Strathfield Local Planning Panel Meeting

TO: Strathfield Local Planning Panel Meeting - 2 May 2019
REPORT: SLPP – Report No. 1
SUBJECT: DA2019/021 - 29 REDMYRE ROAD, STRATHFIELD
LOT 2 DP 935180
DA NO. 2019/021

Proposal: Conversion of part of existing dwelling to an orthodontic practice operating from Monday to Friday 8am-5pm, provision of onsite car parking and tree removal.

Figure 3: Original vehicle parking area

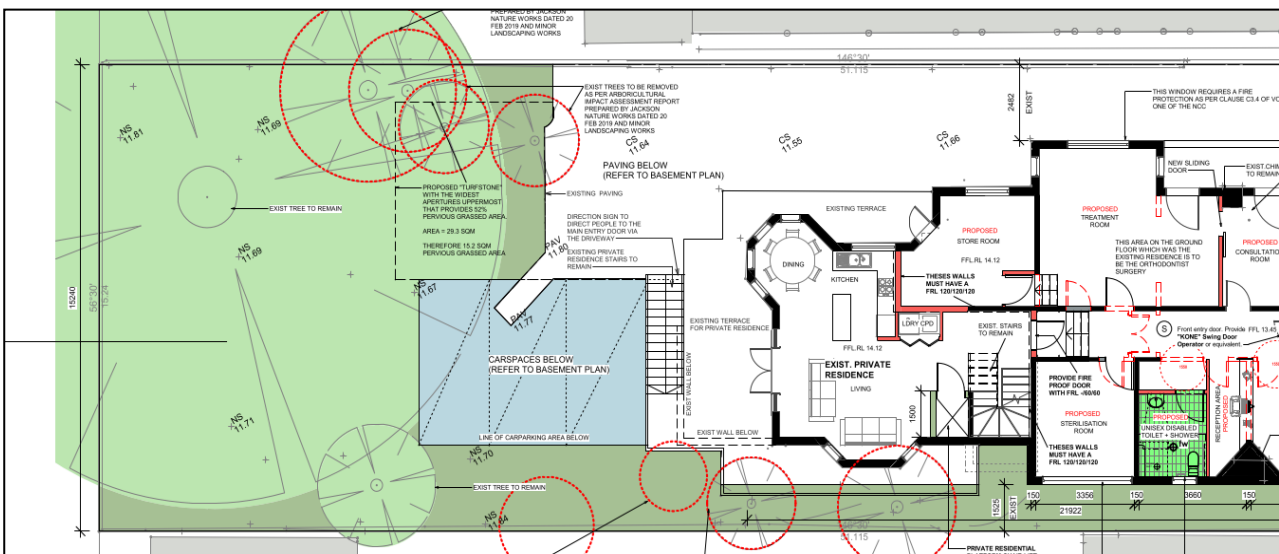
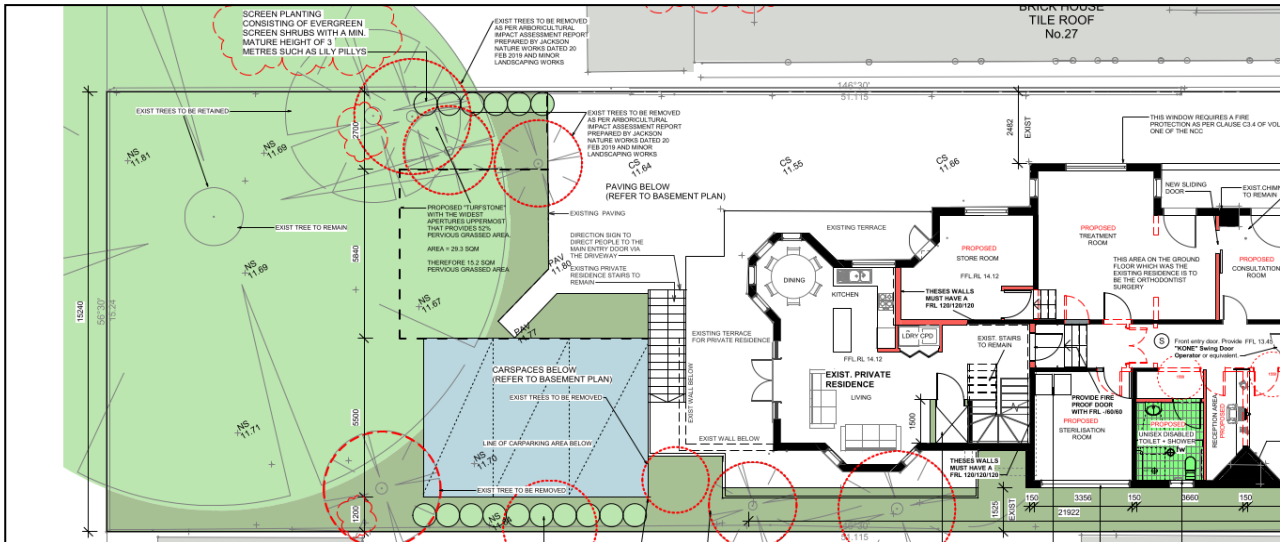
17 April 2019: Correspondence was sent to the applicant that requested the re-location of the proposed vehicle parking area and turning bay to provide additional separation between the retained trees.

During the assessment process Council’s Tree Management Officer raised concerns regarding the retention and protection of Trees No. 5 and 6 due to the close proximity of the proposed vehicle parking and maneuvering area to the Tree Protection Zone (Figure 3). In order to provide adequate separation between the proposed structures and trees to be retained, the vehicle parking and maneuvering area was re-located 1500m towards the western boundary (Figure 4). Council’s Tree Management Officer offered no objections to the revised on-site parking arrangements and the removal of multiple trees subject to the recommended conditions of consent including replacement planting.

Amended plans were submitted re-locating the proposed vehicle parking area and turning bay 1.5m towards the western boundary. Council's Tree Coordinator offered no objections to the amended design. It is recommended that two (2) replacement canopy trees are planted with their location approved by the project Arborist prior to the issue of a Construction Certificate.

Figure 8: Extract from architectural drawings (east and west elevations).

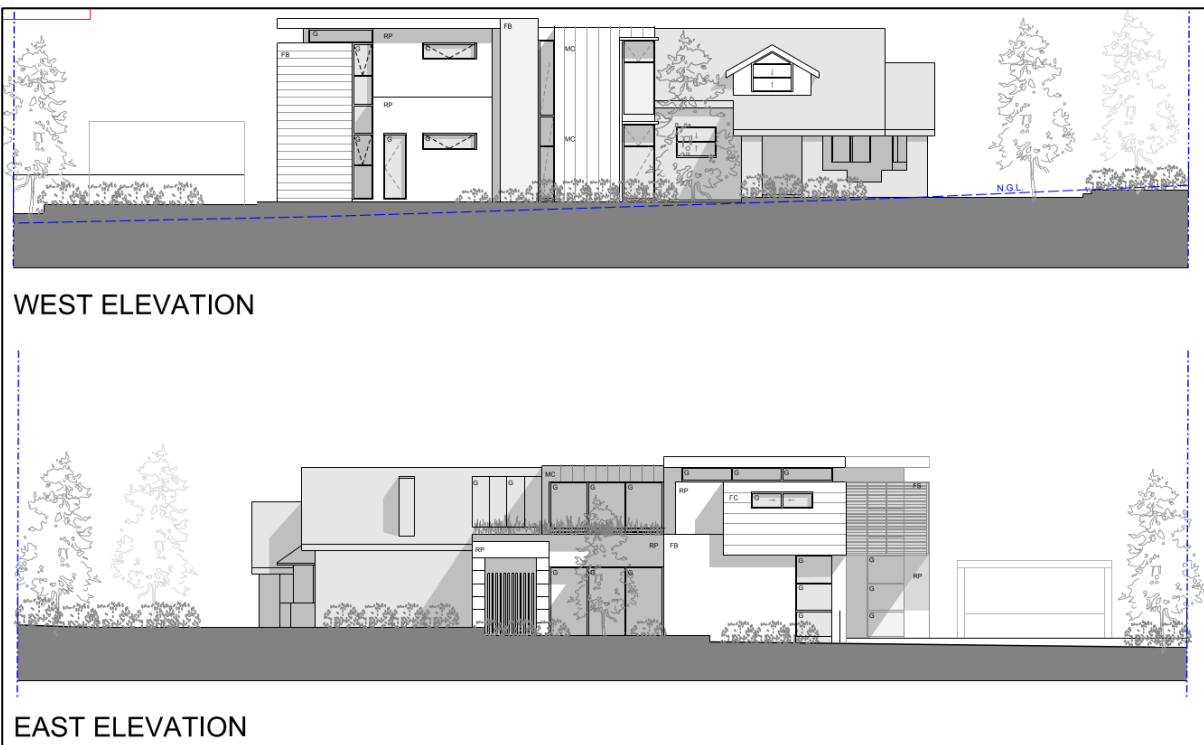
I have reviewed the amended plans (Revision 03, dated 12.04.19) submitted having regard to the provisions of Part P of the SDCP2005 and Clause 5.10 of the SLEP2012. The amended plans involve an alteration to the roof form, including a deletion of the multiple-ridged zig-zag roof form (max RL38.00) which is a positive amendment to the scheme.

Figure 9: Extract from architectural drawings (south elevations), left image received 15 March 2019 and right image received 15 April 2019.

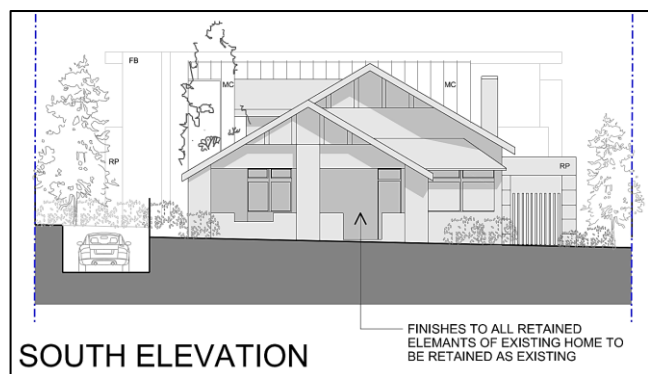
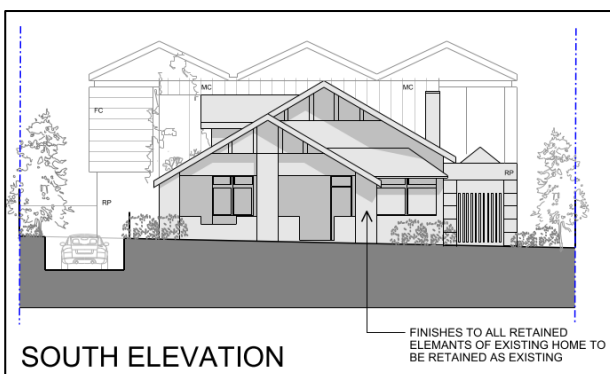
Comments: The proposal will keep the front portion of the neutral dwelling, which maintains the streetscape presentation. The rear addition is contemporary in style proposing a flat roof form and the building materials chosen are sympathetic to the existing dwelling and do not detract from its heritage significance and juxtapose the original fabric from the proposed addition. The building is not a contributory building in the conservation area and the proposed addition is considered to respect the original building by not detracting from the cultural significance of the original dwelling within Merley Road Conservation Area. A pyramidal roof form was proposed in the amended plans (Figure 9), however this design did not achieve the street rhythm and a flat roof reduced the bulk and scale of the addition. The portion of the rear addition and basement entrance adjacent the south western boundary is visible from the street is considered acceptable due to the modern high quality materials and colours and improved landscaping design.
